Electronic Pressure Relief Valve (EPRV) Delete & Fuel Rail Pressure Sensor Update

Mack Trucks has identified through Remote Diagnostics that the vehicles in this Service Campaign have experienced faults with the Electronic Pressure Relief Valve (EPRV). To address this issue, follow the repair outlined within this bulletin to remove the EPRV, Update the Fuel Rail Pressure Sensor (FRPS) and wiring harness, followed by running an accessory kit to reprogram the vehicle.

EPRV Delete & FRPS Update

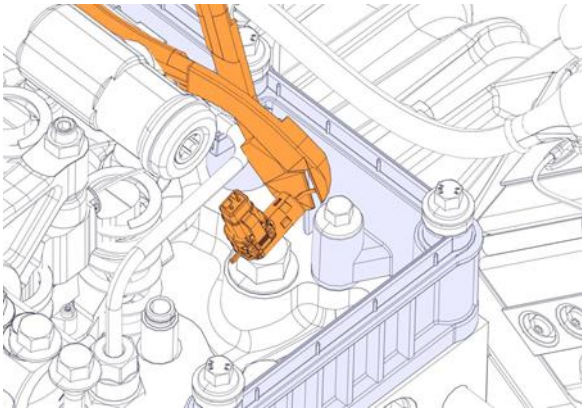
- 17. A product improvement has been made to the Fuel Pressure Sensor (FRPS) and its wiring harness. A visual inspection of the FRPS electrical connector will indicate which sensor and wiring harness is on the vehicle.

18. Inspect the FRPS, if the old-style connector is found (Displayed above with red X), replace the sensor and wiring harness per Impact Instructions listed below. If the new improved connector is found, no farther action is needed and proceed to next step.
 - a. 2373-03-03-06 Pressure Sensor, Common Rail, Replacement, Valve Cover Removed.
 - b. 2861-03-03-03 Wiring Harness, Injector, Replacement (Rear), Valve Cover Removed
19. Refer to IMPACT document ID: 2115-03-02-02 *Valve Cover, Replacement* for valve cover install procedure.
20. Using PTT Operation 1700-22-03-06 Program accessory kit: **85156014**
Note: Running this kit without removing the ePRV will result in adverse vehicle affects.
